**Station Area Redevelopment – CB1
Planning Application Reference: 06/0008/OUT**

This letter is to lodge an objection by Cambridge Cycling Campaign to the above planning application on matters relating to cycling and transport.

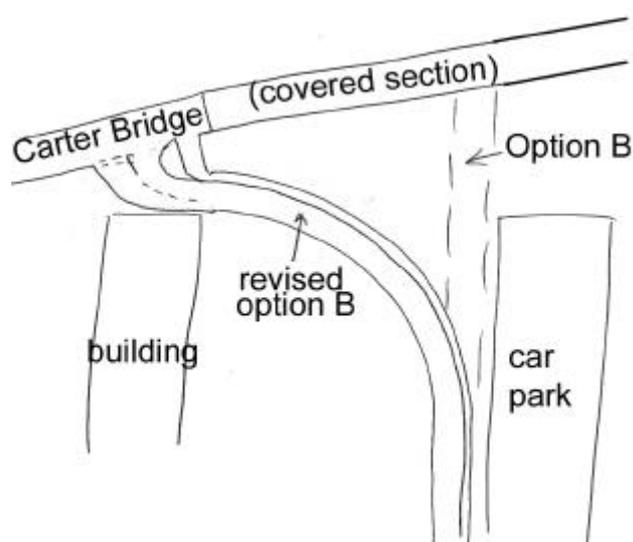
While we welcome option B (a straight ramp), we are advised by a structural engineer that it is unlikely to be structurally practical as proposed. We think it would not be difficult to join such a ramp at a point opposite the point proposed for option A, and that this should be

provided for as a planning condition if option B as proposed is not workable (see Figure). Whatever the joining point, visibility needs to be considered in *both* directions at the junction with the bridge, so sufficient space must be allowed at the joining point for a large platform.

- 2.4. There must be a ramp with a gradient no greater than 5% leading from the south side of the Carter Bridge directly into the station area suitable for use by cyclists and pedestrians.
- 2.5. The ramp from Carter Bridge must pass over or under the car park entrances.
- 2.6. The ramp must be constructed to at least the same standard (total width, allocation between cyclists and pedestrians, and separation method) as the existing bridge.
